# Water Supply System Designs for Nidori, Panama

La Ensenada - Nidori, Panama

Logan Anderson, Kellie Heiden, Madie Martin, Tia Scarpelli, and Adam Tuff

#### Slide 14

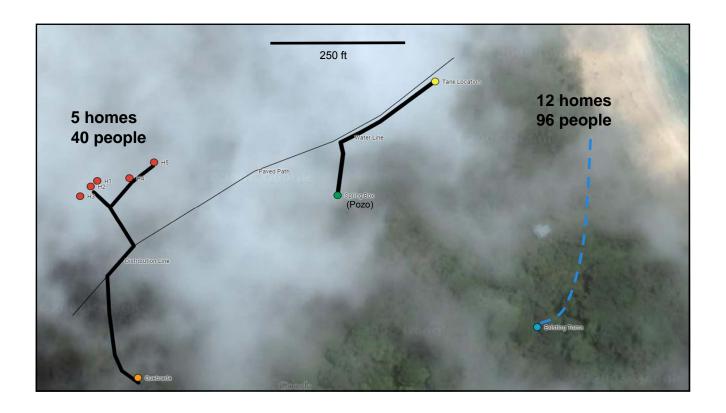
1 Move closer to beginning Adam Tuff,

#### **Quebrada: Project Background**

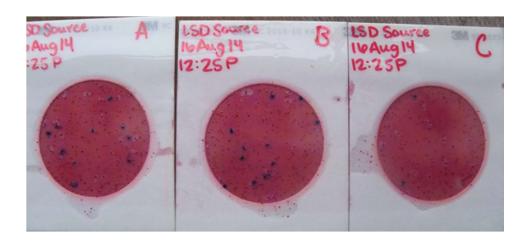
2 Add Quebrada and Pozo to each slide.

# Quebrada: Water Availability v. Demand

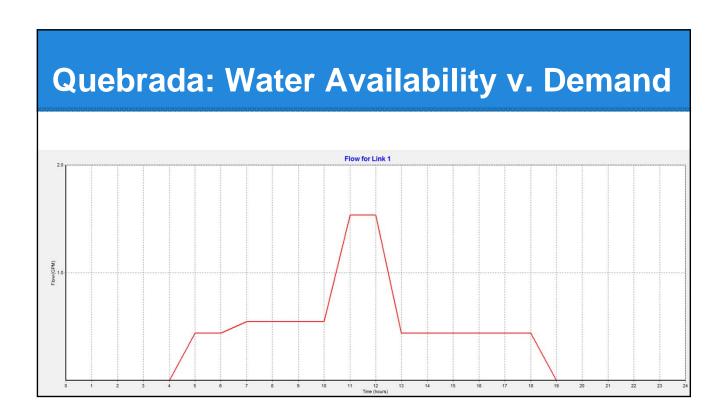
be prepared to justify this demand pattern, different from the previous group and our other pattern. Say that it is because it is plumbed in, and we tried it in epanet with both demand patterns and both worked
